ENCLOSURE 5

Marked up USAR Section

13.3.3 SAFETY PROTECTION SYSTEMS

CONFINEMENT BOUNDARY SKETCH FOR 32PHB DSC

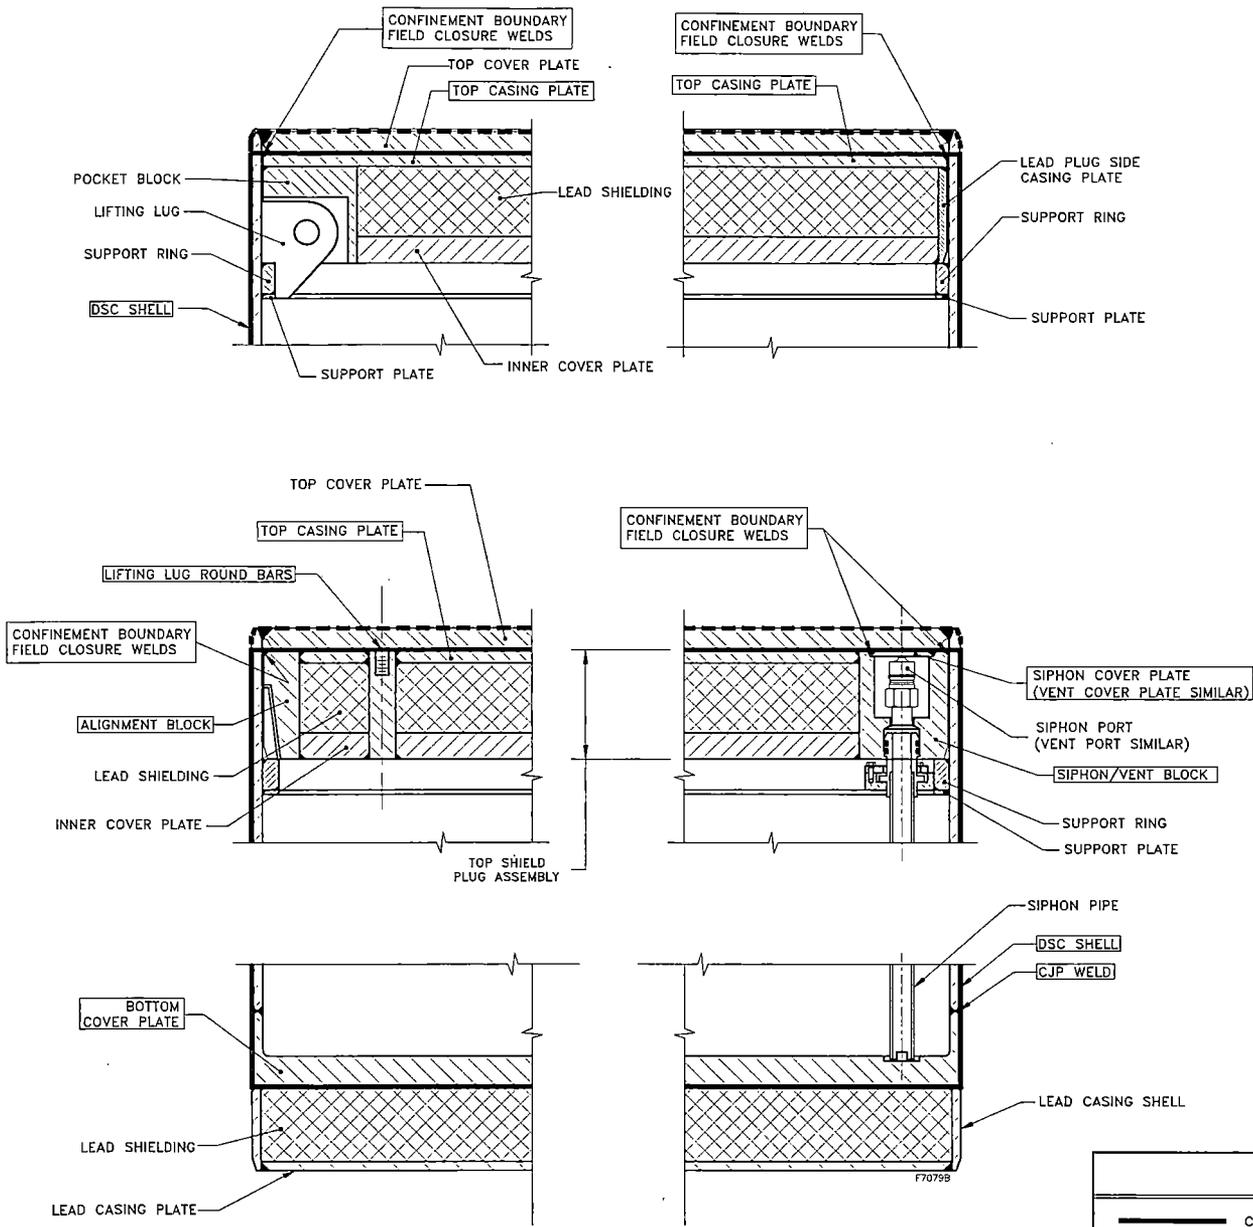
Replace
with
Inset 1

The NUHOMS-32PHB DSC provides leaktight confinement of the spent fuel. The identified confinement boundary, including all base metal components and welded sections, is leak tested to leaktight criteria to verify the integrity of the confinement boundary. The maximum acceptable leakage is $1E-7$ atm cc/s He, which is bounded by the maximum acceptable leak rate per American National Standards Institute (ANSI) N14.5, "Radioactive Materials – Leakage Tests on Packages for Shipment." Thus the NUHOMS-32PHB DSC is considered to be leaktight per ANSI 14.5-1997.

The physical design of the confinement boundary for the NUHOMS-32PHB DSC is identified in Transnuclear drawings NUH32PHB-30-1 and NUH32PHB-30-4 as follows:

1. Item 52: Siphon/Vent block (component of top shield plug assembly Item 50)
3. Item 53: Alignment block (component of top shield plug assembly Item 50)
4. Item 54: Top casing plate (component of top shield plug assembly Item 50)
5. Item 58: Lifting lug round bars (component of top shield plug assembly Item 50)
6. Item 2: DSC Shell
7. Item 10: Bottom cover plate

The associated shop and field welds between the above components are also part of the confinement boundary and are constructed to meet the American Society of Mechanical Engineers Section III, Subsection NB requirements.
